Requirement Updates for Dolby Decoders in DVB Consumer Broadcast Receivers

Technical Bulletin 11, 2010 Update

This technical bulletin updates Dolby® requirements for consumer broadcast receivers intended for DVB markets. Requirements for all other products remain as stated in the documents relevant to those products.

Figure 1 Dolby Digital and Dolby Digital Plus in RF Mode (Draft Courtesy of EBU)

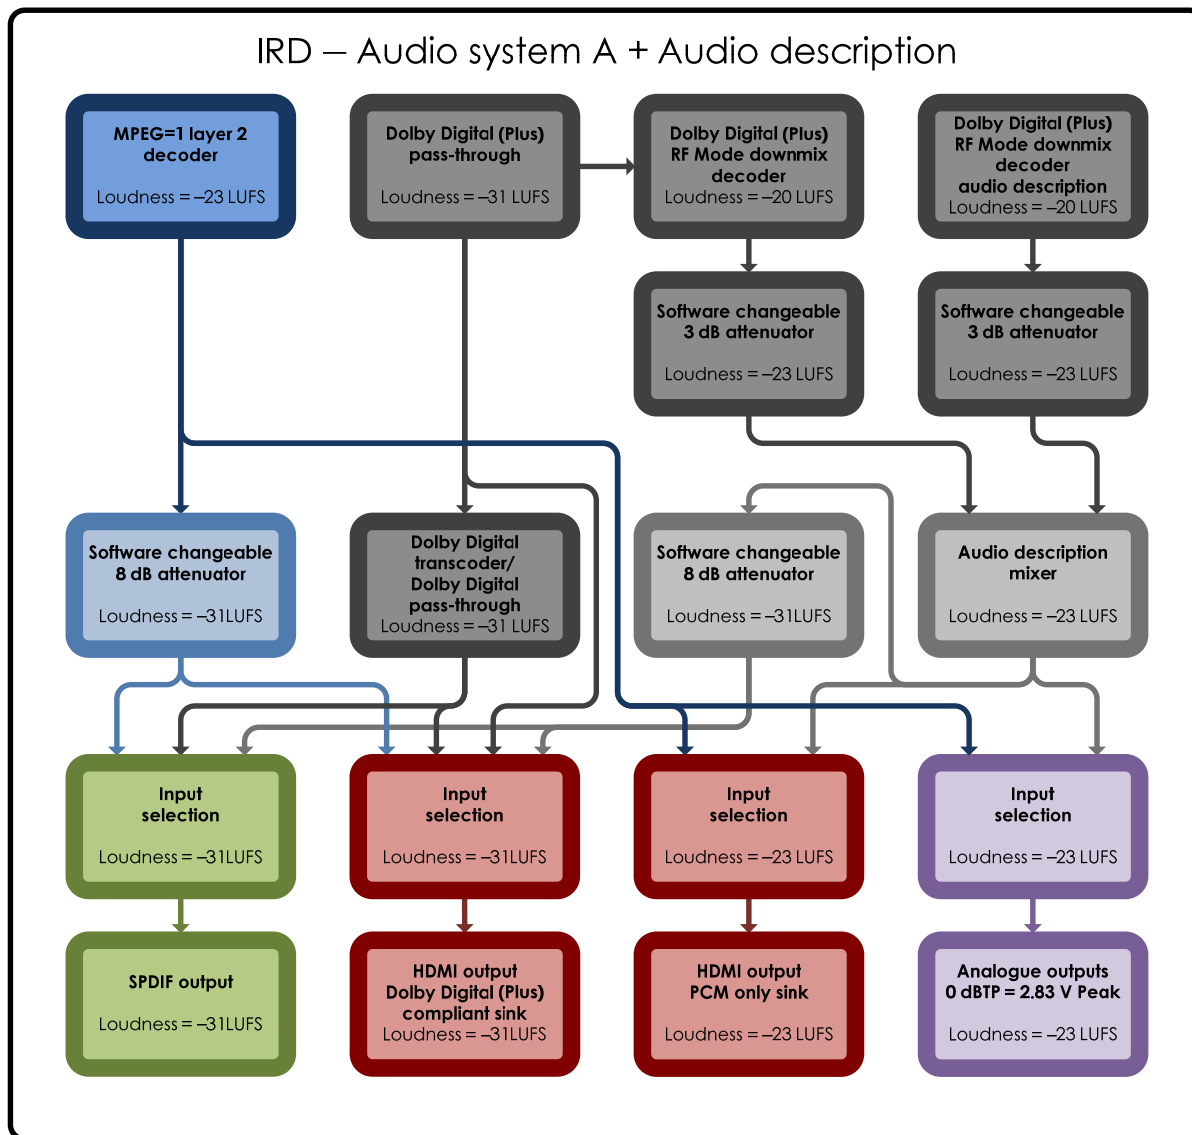
Tip: You can achieve level matching by setting the dynamic range control to RF mode (providing 11 dB gain, which boosts the -31 LUFS program to -20 LUFS) and then attenuating the output by 3 dB, resulting in a loudness of -23 LUFS.

The EBU recommendation for the level-matching method is shown in Figure 1.

Figure 1, based on a draft by the EBU, shows an example of matching loudness from Dolby Digital and Dolby Digital Plus programs with MPEG-1 LII programs. (Note that the diagrams are based on a draft revision of EBU Tech 3333 not yet published at the publication date of this document.)

1. The Software changeable 3dB attenuator block in Figure 1 can be located after audio description (main/associated program) mixer.
2. Loudness = -31 LUFS in the Dolby Digital transcoder and Dolby Digital pass-through blocks (Figures 1 and 2) indicates a decoder operating in Line mode and applying dialogue normalization metadata (`dialognorm`) to normalize the output level to -31 LUFS.
3. Loudness = -23 LUFS in the HE AAC downmix decoder block in Figure 2 is achieved in Dolby Multistream MS10 decoders by setting the default `dialognorm` value to -23, applying RF mode dynamic range compression, and subsequently applying 3 dB attenuation (as in Figure 1).

Figure 2 HE AAC Decoding (Draft Courtesy of EBU)

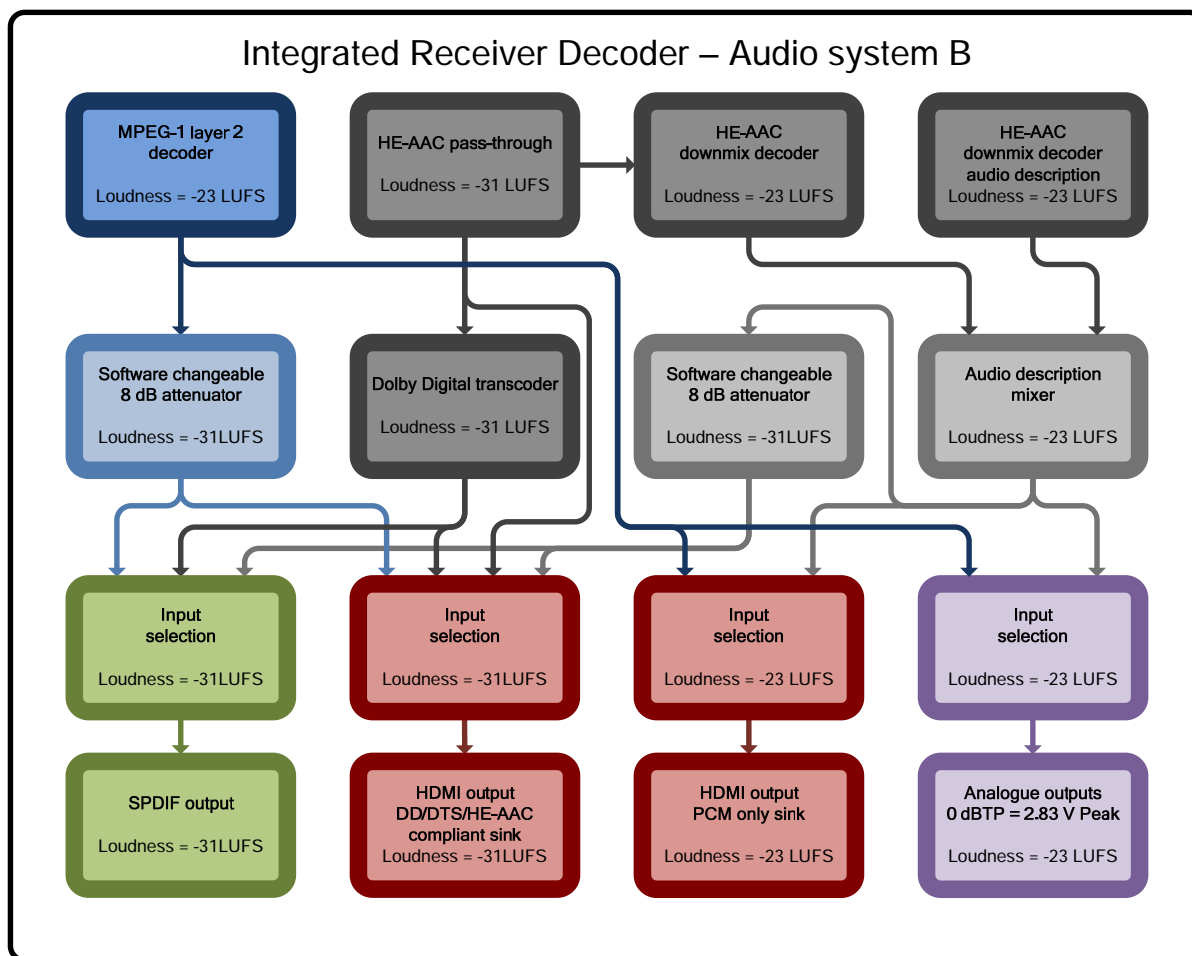
Figure 2 shows an example implementation for HE AAC (without metadata) recommended by the draft revision of EBU Tech 3333.
